# Interaction of Electromagnetic Pulse with Commercial Nuclear Power Plant Systems

Main Report

NUREG/CR-3069, Vol. 2  
SAND82-2738/2  
AN, 1S, 9E, 9U

This study examines the interaction of the electromagnetic pulse from a high altitude nuclear burst with commercial nuclear power plant systems. The potential vulnerability of systems required for safe shutdown of a specific nuclear power plant are explored. EMP signal coupling, induced plant response and component damage thresholds are established using techniques developed over several decades under Defense Nuclear Agency sponsorship. A limited test program was conducted to verify the coupling analysis technique as applied to a nuclear power plant. The results are extended, insofar as possible to other nuclear plants. Based upon the analysis, it was concluded that: (1) Diffuse fields inside Seismic Class I buildings are negligible; (2) EMP signal entry points are identifiable; (3) Interior signal attenuation can be reasonably modeled; (4) Damage thresholds, even for equipment containing solid state components are high; (5) EMP induced signals at the critical equipment in the example plant are much less than nominal operating leve

Figure A-2a. 500 kV Transmission Line Model

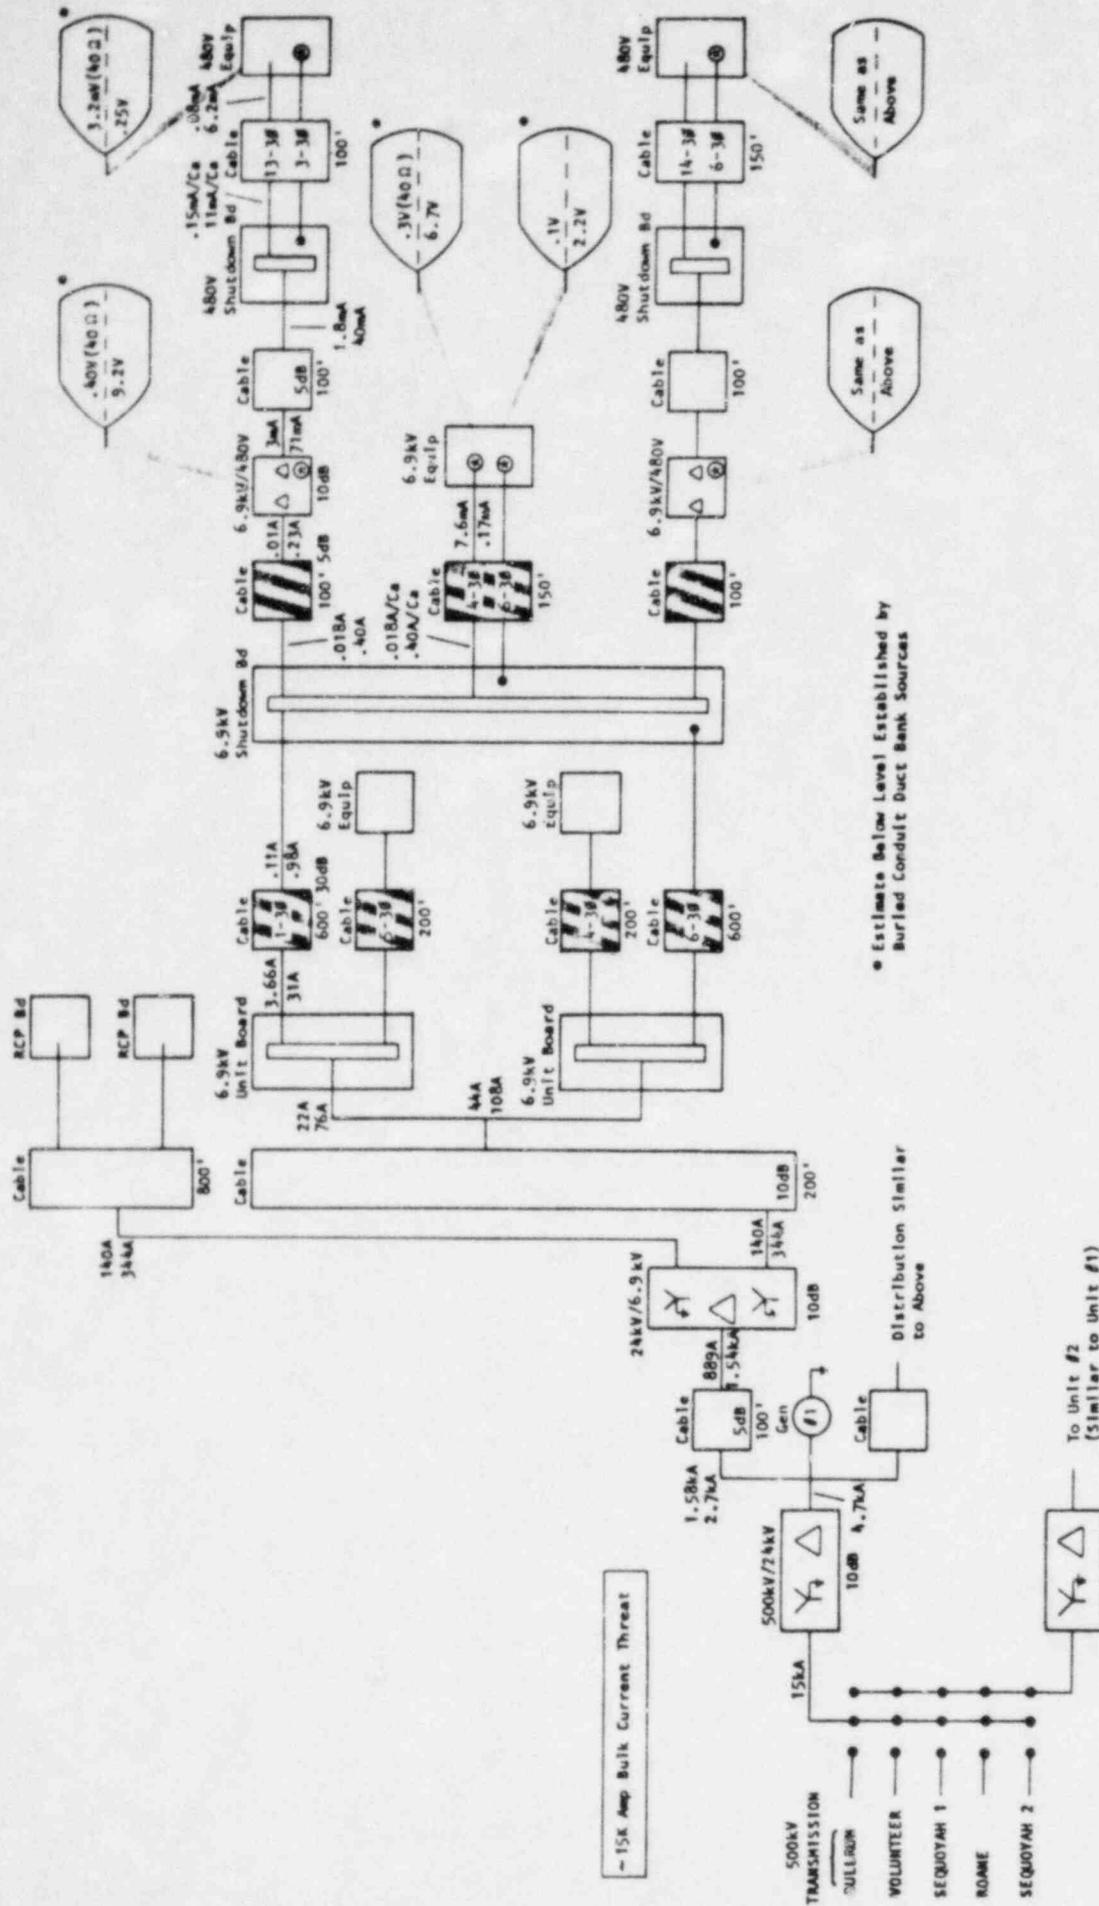
5. It would be helpful if the backup data and calculations are included in the Appendix A for the 500 kv transmission model for the derivation of surge currents as shown in Figure A-2.
